RE: Brookside Village – 15 Upper Main Street

We are writing on behalf of Dousevicz Inc., c/o Brad Dousevicz, to respond to issues raised by Town Engineer, Aaron Martin and Public Works Director, Dennis Lutz during their preliminary plan review as outlined in the attached April 8, 2015 memo. Questions and Comments are italicized below and our responses follow each of your questions.

Subject: Brookfield Village, 15 Upper Main Street
Preliminary Plan Review

METER VAULT AND PIPING PLAN VIEW		DATE: MARCH 2013
CWD SPECIFICATION		DRAWING No. A-34
DESIGNED BY: ---	CHECKED BY: ---	SHEET 1 OF 1
1-A-34 Meter Vault Plan.DWG

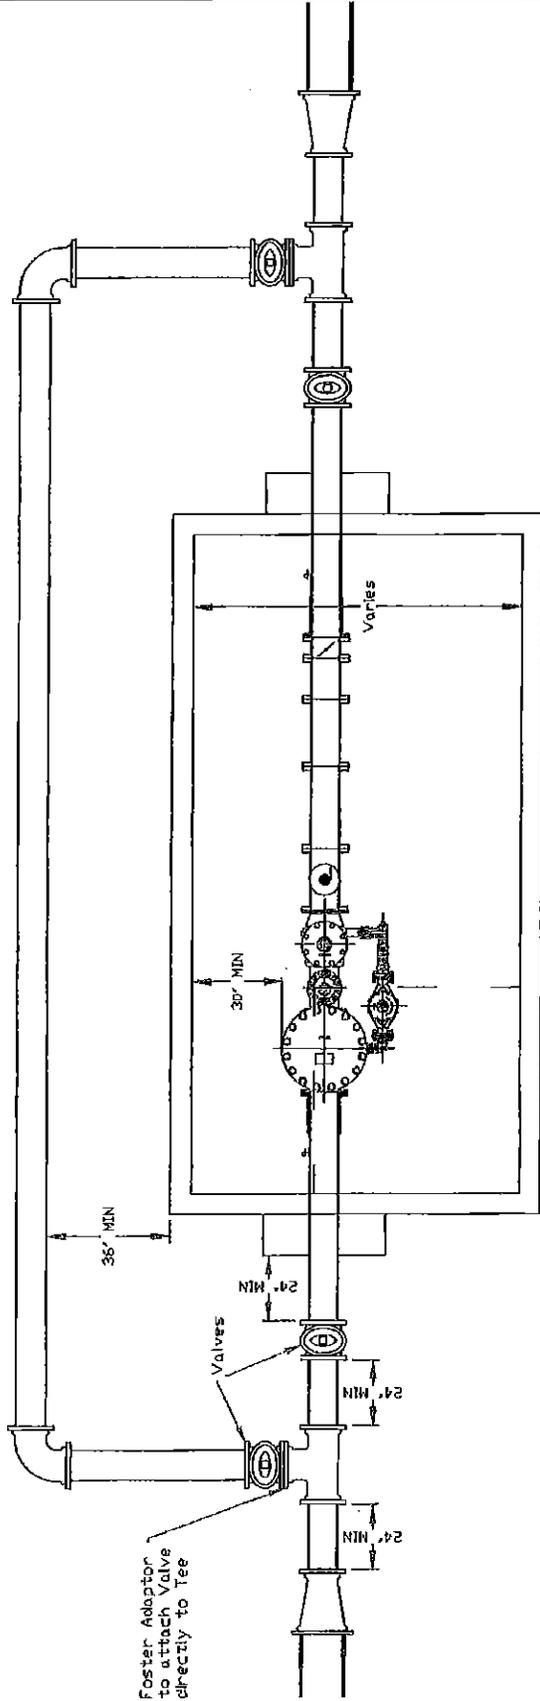
- 3) *Approval from the Village for all new municipal water infrastructure located within the Village to make the connection.*
 - 4) *A new meter vault between the Village system and the proposed system within the Town to meter all water crossing from the Village to the Town. The meter vault is required between CWD communities to accurately reflect the water use between the two communities. It shall be designed and constructed to meet Champlain Water District standards, see attached. There are no exceptions to the requirement and it applies whether or not the water system is private or public.*

- 3) Approval from the Village for all new municipal water infrastructure located within the Village to make the connection
 - 4) A new meter vault between the Village system and the proposed system within the Town to meter all water crossing from the Village to the Town. The meter vault is required between CWD communities to accurately reflect the water use between the two communities. It shall be designed and constructed to meet Champlain Water District standards, see attached. There are no exceptions to this requirement and it applies whether or not the water system is private or public.

As requested a new meter vault designed to standards from the Champlain Water District has been proposed to accurately meter usage between the Town and Village, see SH 3 '30-Scale Site Plan B' and SH 7 'Water & Stormwater – Details and Specifications'. A 30'x40' easement, to the Town of Essex, centered on the water meter vault has been proposed to allow for access and maintenance.
